CAPITOL ZONING DISTRICT COMMISSION
STAFF REPORT
10/26/2016
TDM / BIM

Location: 1424 South Main Street
Applicant: Matt Foster
Permit Types: Certificate of Appropriateness

Project Description: The applicant seeks a Certificate of Appropriateness to demolish the structure located at 1424 S. Main and to construct a new two story mixed use building. The building will be covered mostly with brick with glass and wood storefront facades on the ground level, balconies for the residences on the second level, and covered roof-top decks on the top. Both the 15th and Main Street sides will be built to the lot line adjacent to the sidewalks. Parking will be located at the rear, with some located across the alley as part of a shared parking agreement with a nearby property. No specific uses for the ground floor rental spaces are being proposed at this time.

SITE PLAN
 A1.0

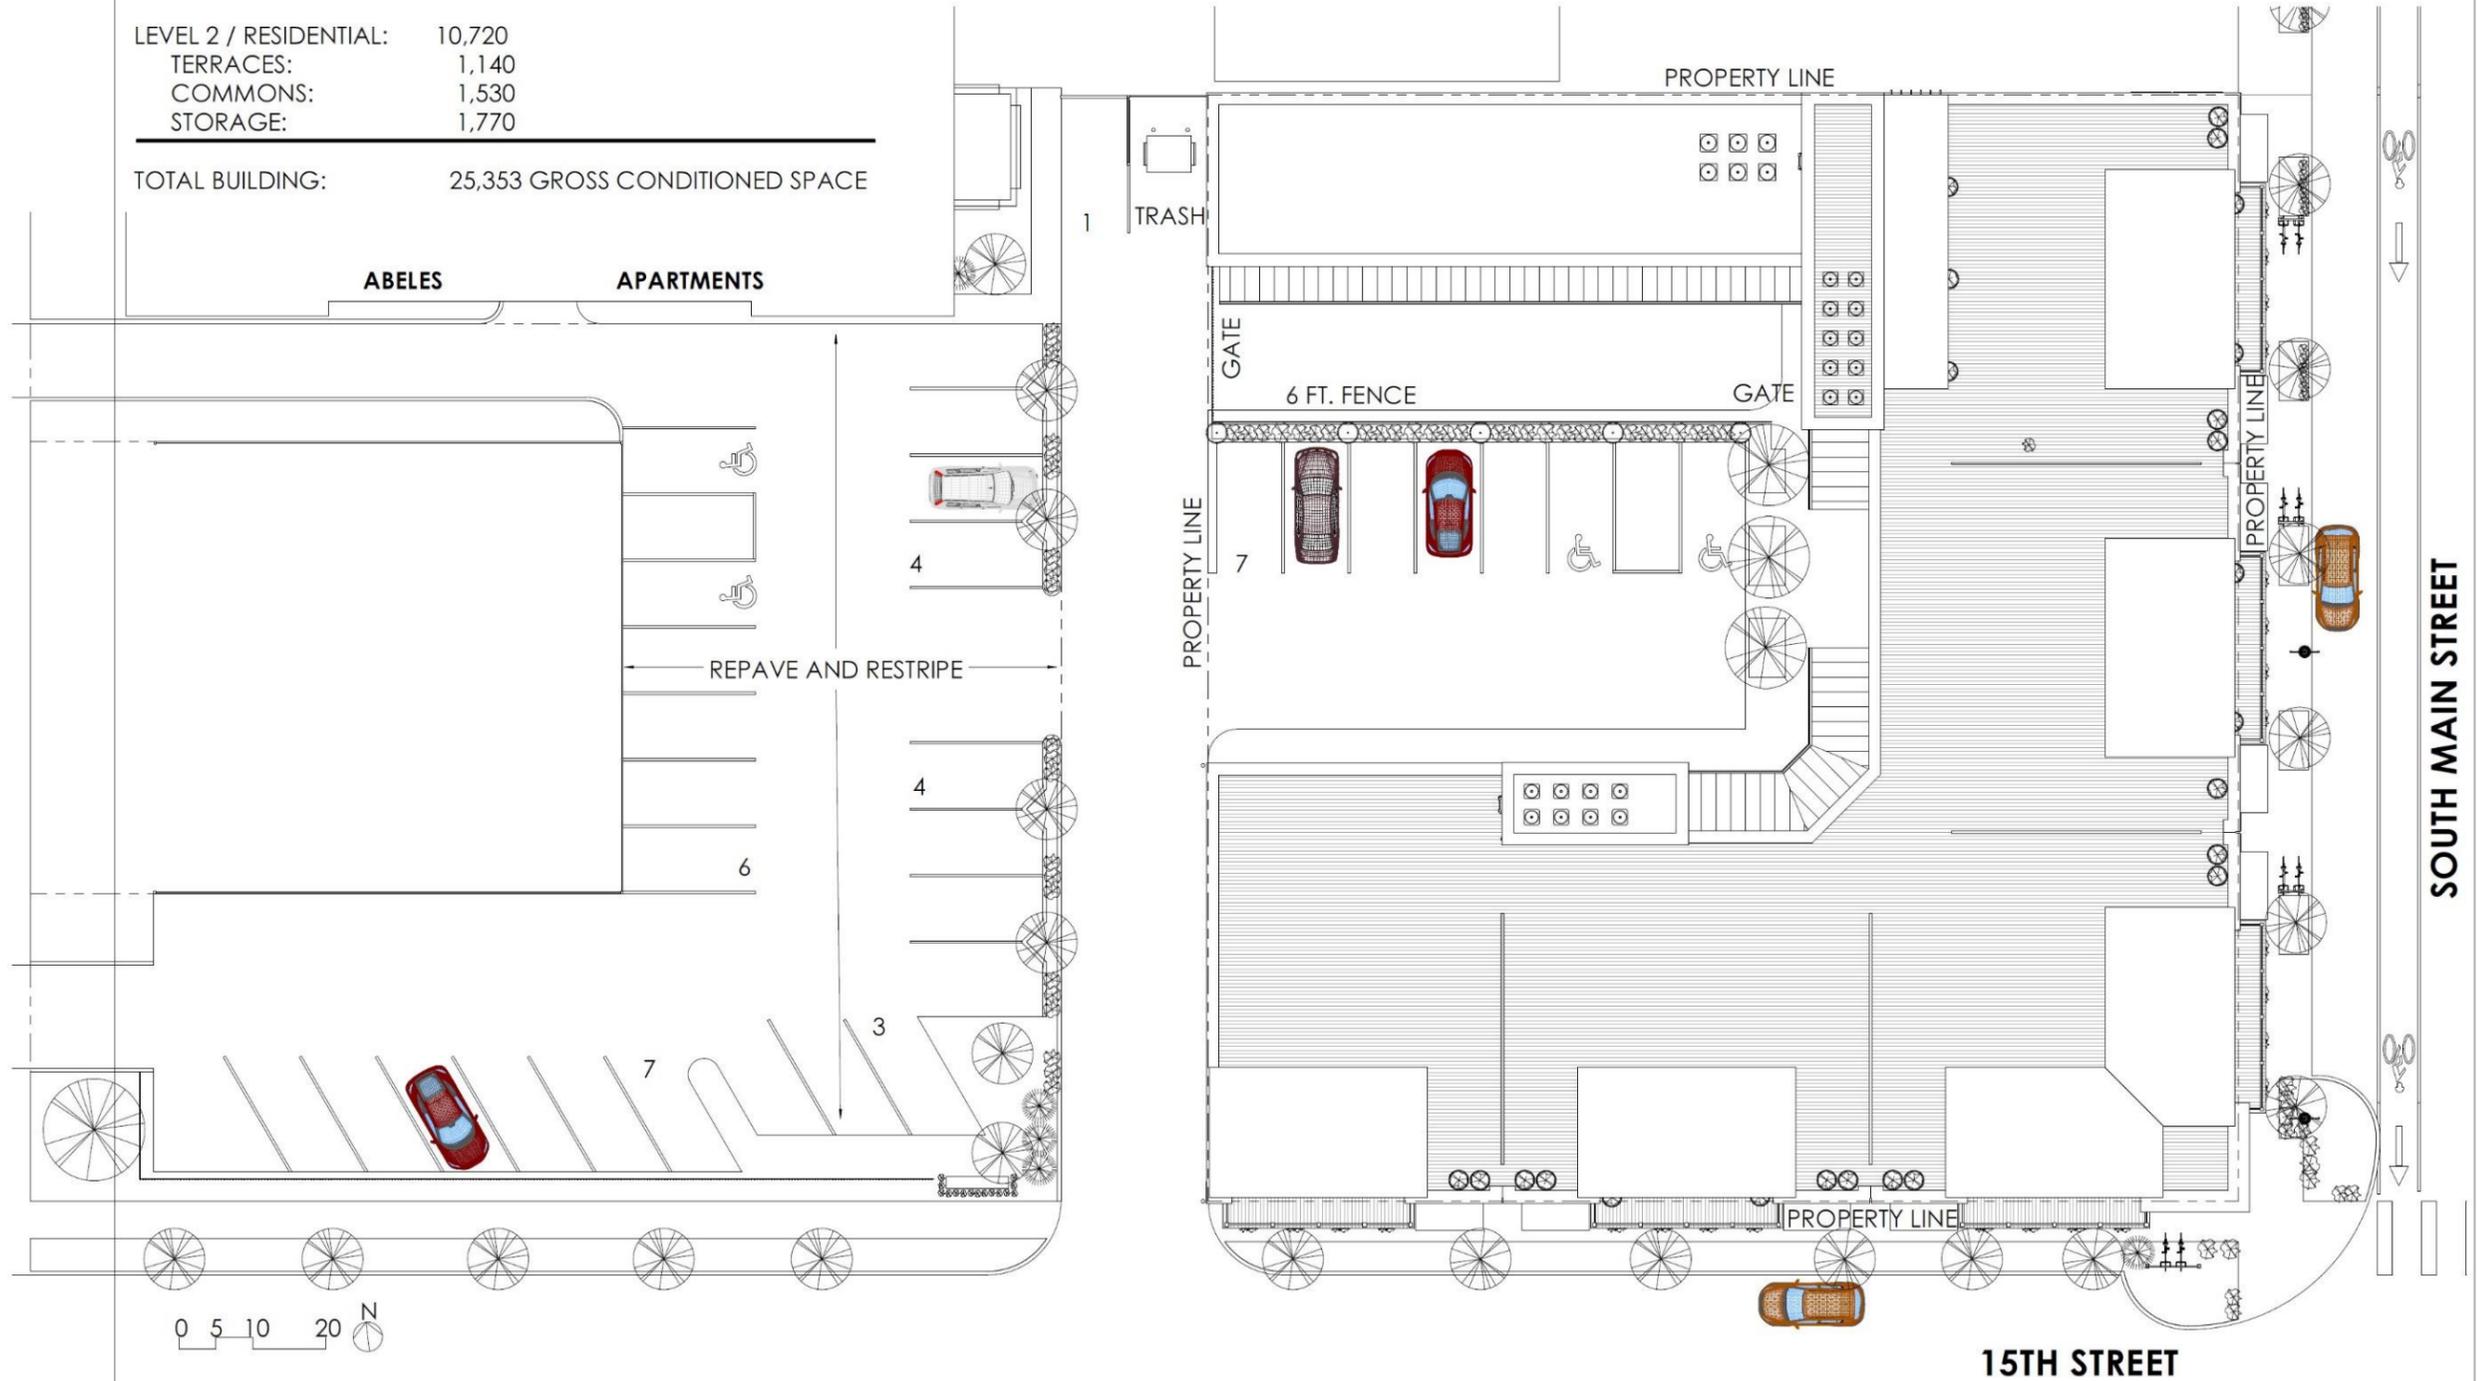
Staff finds the proposal to be consistent with these requirements. The proposed structure will be built to the sidewalks on both the Main Street and 15th Street sides. The lot covers 20,473 square feet according to the Pulaski County Assessor. The building's proposed 25,353 square foot area is within the 1.5:1 F.A.R. requirement, and the proposal to build five residential units is easily allowed by the 1,200 sq. ft. minimum lot area per unit requirement. The majority of the two-story building will be below 35 feet tall. The rooftop pergolas, elevator shaft, and mechanical screening will all be below 45 feet tall.
